Infonote

AO-IN-2022-018-I

New tray design and Removal of Inner Transportation Box for LED Engin LZP devices

15.06.2022

Description of change

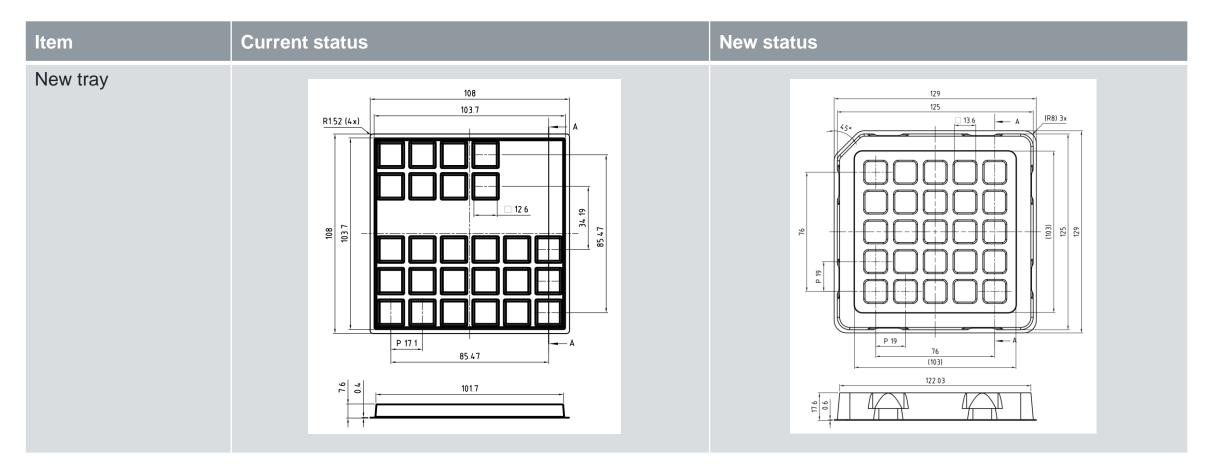
Objective:	New tray design for LZP devices Removal of Inner Transportation Box		
Affected products:	LZP-00MD00 LZP-00MN00 LZP-04UB0R LZP-00T30R		
Reason for change:	Introduce polarity marking on the trays. Improve stacking behavior of the trays. Enable automatic pick and place. Waste and CO ₂ savings		
Description of change:	With inner transportation Box	New Status New Tray Without inner transportation Box document 2_cip_AO-IN-2022-018-I	
Documentation:	Customer information package 2_cip_AO-IN-2022-018-I		
Time schedule:	June 20 th , 2022
